**Valentine Gold Project: Federal
Information Requirements**

Response to IR-59 to IR-76

Marathon Gold Corporation
36 Lombard Street, Suite 600
Toronto, ON M5C 2X3

May 2021

FIGURE
IR63-1

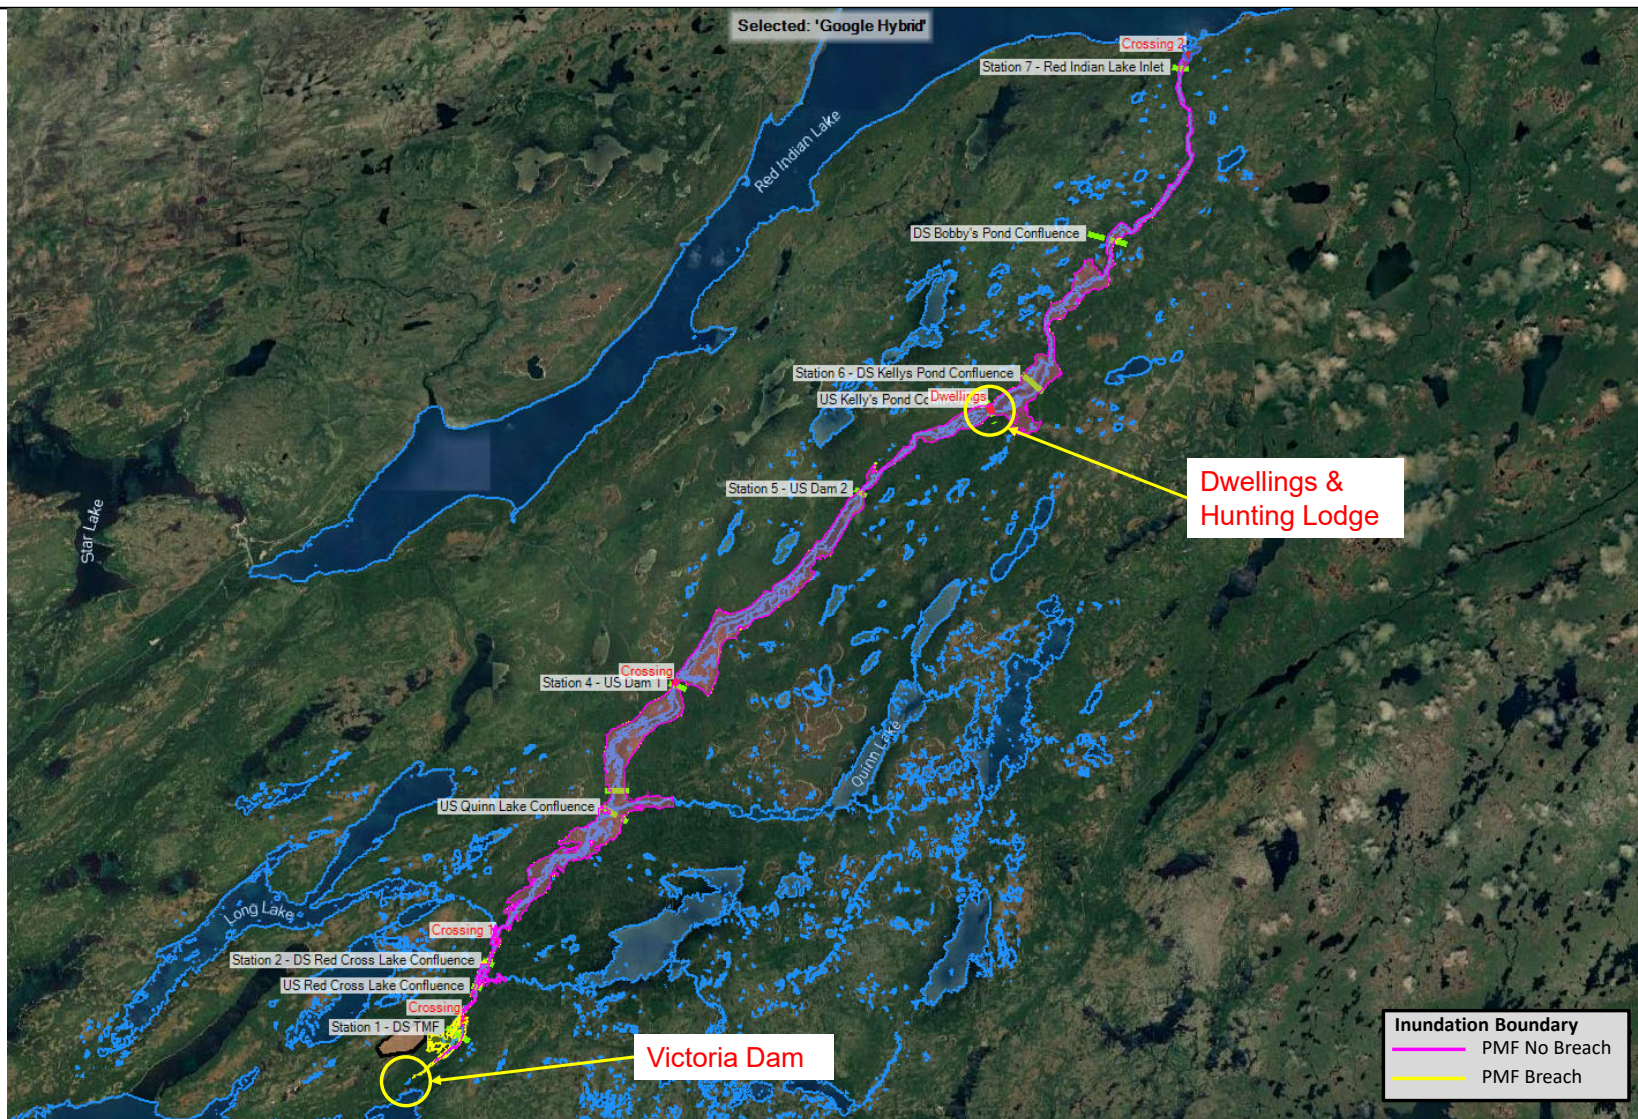
Information Request:	<p>In consideration of the available data, update the effects assessment by using PMP estimates based on updated/longer periods of record, including for stations closer to the project site or provide a rationale for using the older data that is lower than updated PMP estimates.</p>

ID:	IR-63
	<p>An assessment of the available meteorological data, including the proximity of each station to the Project Area and the quality of data available from each meteorological station, is presented in the response to IR-72. Based on the available meteorological data, in consideration of the advancement of the engineering design for the TMF, and to provide a more conservative assessment of potential effects from the Project, the most conservative values for the long-term design precipitation events will be utilized in updating the dam breach analysis as further described below. For final engineering design, alternate probable maximum precipitation (PMP) values may be considered, if further collection and assessment of meteorological data indicate these are warranted. These would be included in the final design information submitted for regulatory review and approval via the permitting process. The PMP value only affects the sizing of the emergency spillway for very high consequence category dams and is used in the DBA.</p> <p>In selection of the PMP value, the Buchans meteorological station (ID 8400698) provides the most conservative data, with a PMP depth of 450 mm. An updated DBA utilizing the Buchans station PMP value is ongoing, and an updated DBA report will be issued separately to this IR response. It is important to note that the DBA will continue to be updated as the detailed engineering for the TMF and associated infrastructure is advanced.</p> <p>At this time, only the flood-induced dam breach model runs have been completed. Figures IR-63.1 to IR-63.3, attached, show the inundation extent under the 450 mm probable maximum flood (PMF) in the Victoria River, with (pink) and without (yellow) a dam breach.</p> <p>In the event of a dam breach under a PMP induced flood, up to a peak discharge of 1,735 m³/s may be released from the TMF. This is approximately 8% to 16% lower than the peak discharge estimated in the DBA presented in the EIS, as a result of ongoing design refinements including relocation of the polishing pond. The incremental impact upstream and downstream of the TMF was assessed relative to the impact of the PMF.</p> <p>Upstream of the TMF, the mild slope of the Victoria River channel is expected to result in backwater flows towards the Victoria Dam. Based on a breach under PMP conditions, the TMF inundation could extend upstream to within 550 m (downstream) of the Victoria Dam, but will not reach the dam toe as was predicted in the DBA presented in the EIS.</p> <p>Downstream of the TMF, a dam breach would result in negligible incremental impact (<0.5%) on the extent of the flood boundary resulting from the natural effects of the PMF. For example, the peak flow under the updated PMP volume (450 mm) at the dwellings and hunting lodge upstream of Kelly's</p>

ID:	IR-63
	<p>Pond confluence is 2,677 m³/s under a breach, compared to 2,654 m³/s with no breach (Figure IR-63.4). As shown in the figure, the incremental effect (water level) due to the dam breach is almost indiscernible (<0.5%) from the natural flood level. This is consistent with the results of the DBA presented in the EIS.</p> <p>The updated DBA results described above result in less impact to the downstream environment than what was presented in the EIS, despite using a more conservative design flood (PMP at 450 mm versus 309 mm). This is a result of design modifications that have been made to the TMF to reduce potential environmental effects and improve engineering efficiency. No further update to the effects assessment or conclusions presented in the EIS is required.</p>
Appendix:	None

Figure 3-3 Estimated Alternative Migration Pathways for Caribou in the Buchans Herd During Spring Migration Under Frozen and Unfrozen Conditions

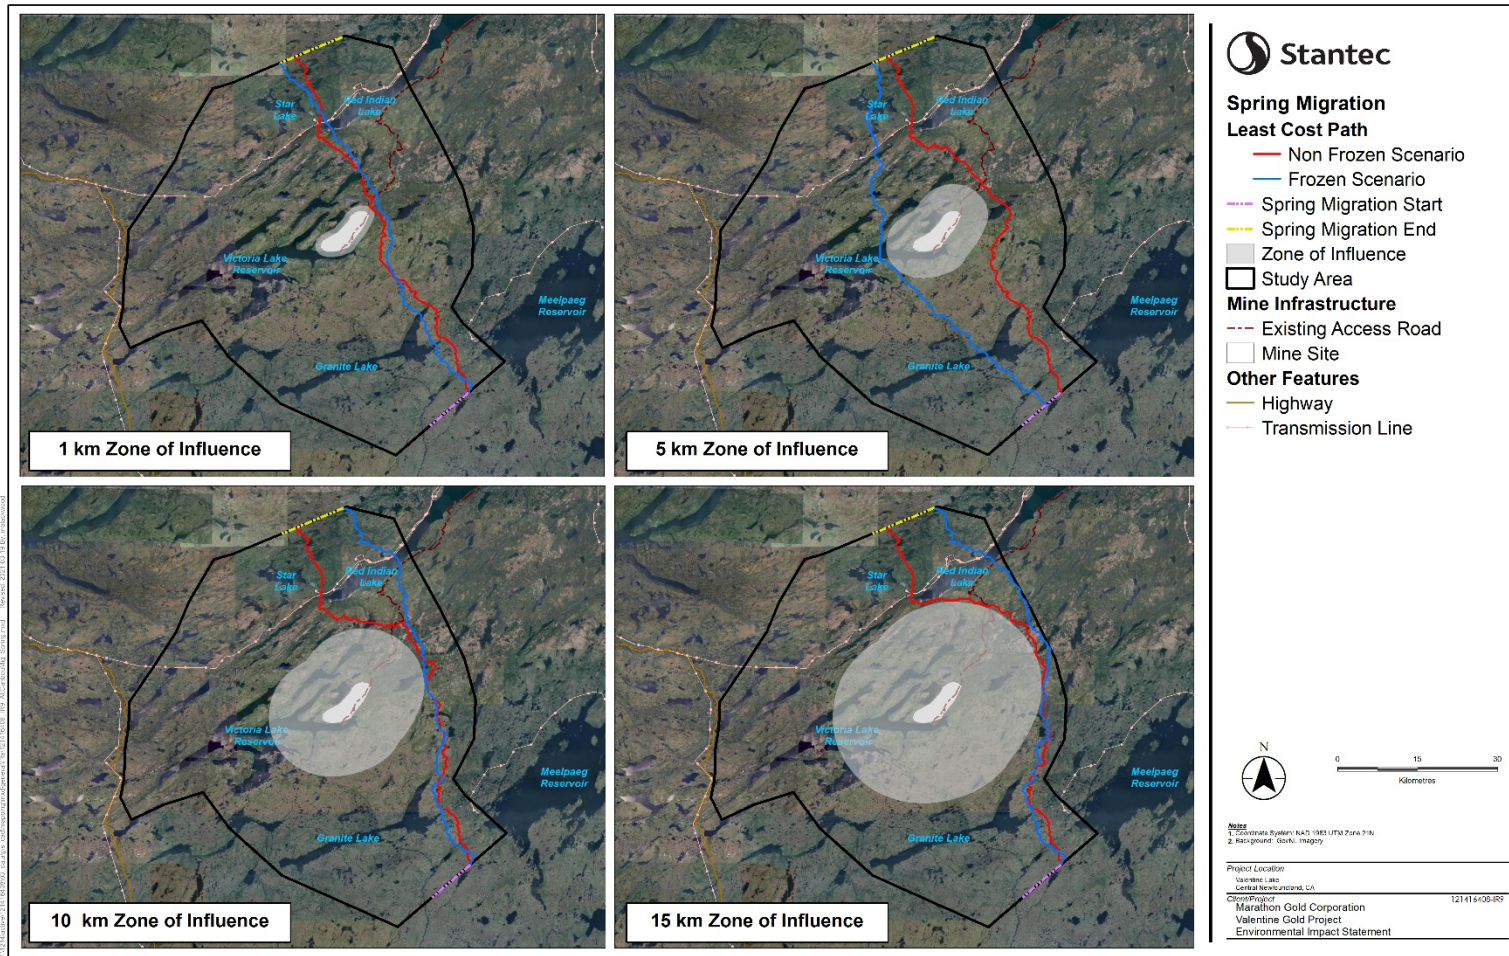
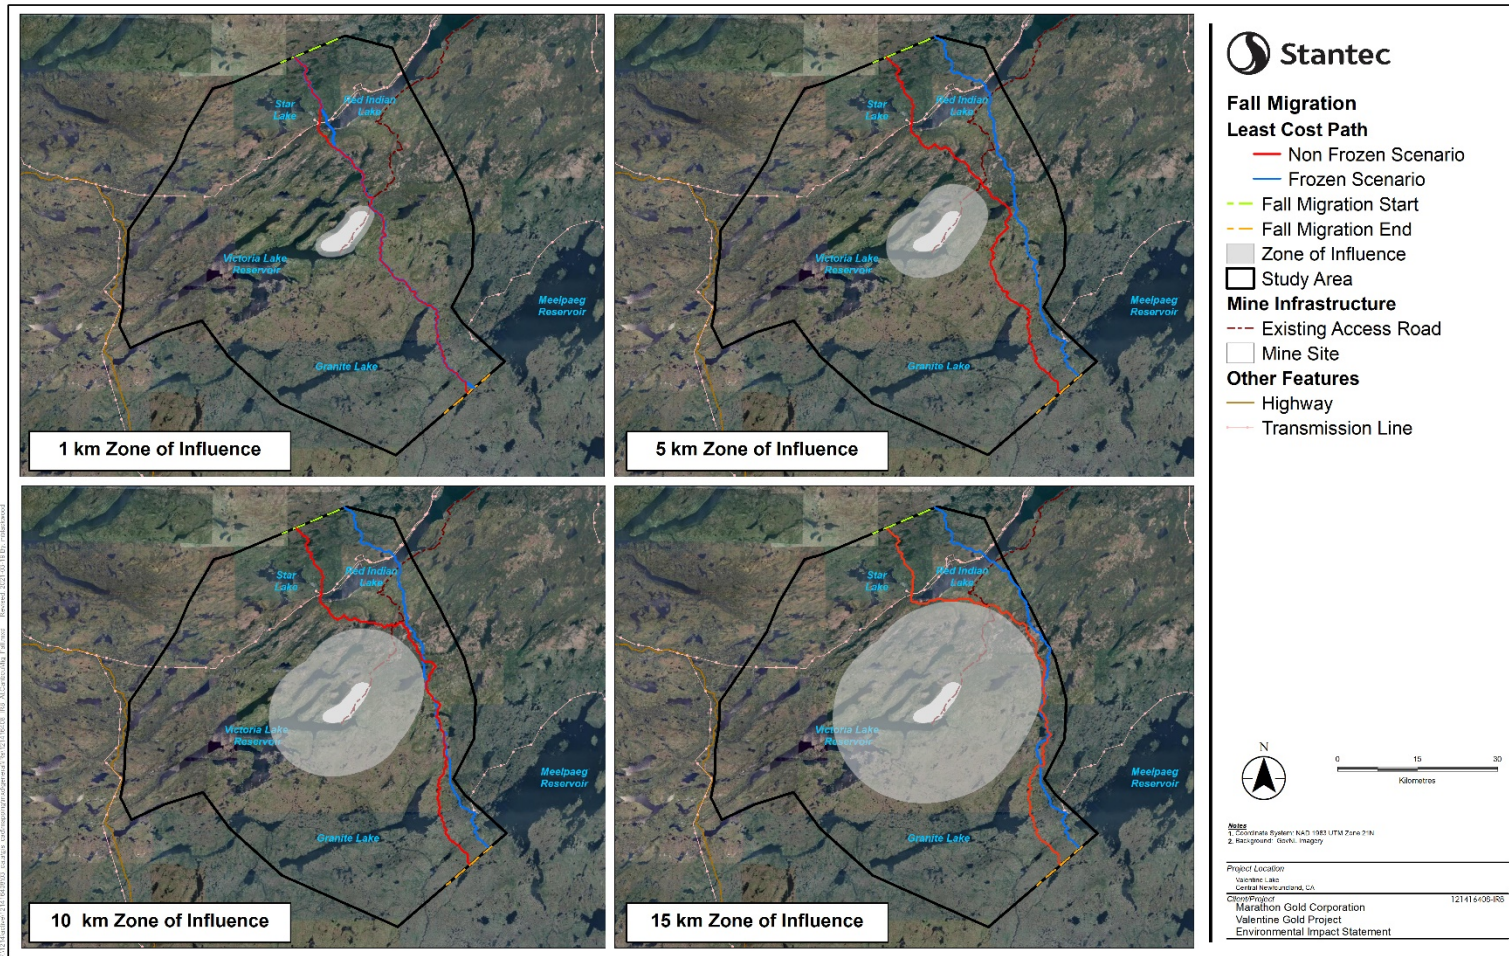
Information Request:	<p>a. Provide a comprehensive assessment of potential effects of the project as a whole (i.e. all project components) on caribou migration, calving</p>

ID:	IR-60
	<p>and subsequently to caribou populations for all phases of the project. Include at a minimum the effects of dust, noise and vibrations on caribou. This must include impacts resulting from stress as well as habitat degradation.</p> <p>b. Provide an assessment of effects and risks for predicted caribou avoidance zones using distances consistent with scientific literature. This must include an assessment of the amount of direct and indirect caribou habitat loss resulting from avoidance at an appropriate distance(s) consistent with scientific literature.</p> <p>c. Describe in detail proposed measures that will be used to mitigate for predicted effects on caribou. This is to include, but not be limited, to targeted mitigations which address permeability of the migratory pathway to caribou and is also to address how the effects of noise, light and particulate will be mitigated during the different phases of the project. Describe in detail any associated monitoring and follow-up and monitoring programs.</p> <p>d. Provide an assessment and discussion of combined project impacts from disturbance, habitat loss, mortality, and potential changes in migration stemming from project development (past, present and future) on affected caribou.</p>

The LCP analyses predicted alternate pathways for each ZOI under frozen and unfrozen conditions during spring migration (Figure 3-3) and fall migration (Figure 3-4). In spring, the alternate pathways navigate around the east side of the mine site at increasing distances with each ZOI, except at the 5 km ZOI under frozen conditions where the alternate pathway moves around the west side of the mine site across Victoria Lake Reservoir. Alternate pathways under frozen conditions are shorter in each ZOI compared to unfrozen conditions because caribou are predicted to travel directly across sections of Granite Lake, Victoria Lake Reservoir, and Red Indian Lake under frozen conditions. In fall, the alternate pathways follow similar routes around the east side of the mine site as the spring predictions for each ZOI and scenario except at the 5 km ZOI under frozen conditions where the alternate pathway moves south across Red Indian Lake and east around the mine site.

The LCP analysis provides conservative estimates of potential alternate migratory pathways that may be used by the Buchans herd if the Project proceeds. The results are conservative because the analyses assume that caribou will completely avoid the mine site and each ZOI tested (i.e., 1 km, 5 km, 10 km, and 15 km). The estimated increase in annual migration pathway length ranges from 0 km to 30 km and the estimated associated cost is 1.01 to 1.41 times greater than baseline. Alternate migratory pathways are likely to exist within the ZOIs as individual caribou may show varying degrees of avoidance of the Project. In other words, the ZOIs may not be complete barriers to all migrating caribou, and some caribou may choose to migrate closer to the mine site than others. For example, Plante et al. (2018) determined that caribou avoid mine sites by varying degrees, with some individuals having a 3 km ZOI and other individuals having a 21 km ZOI.
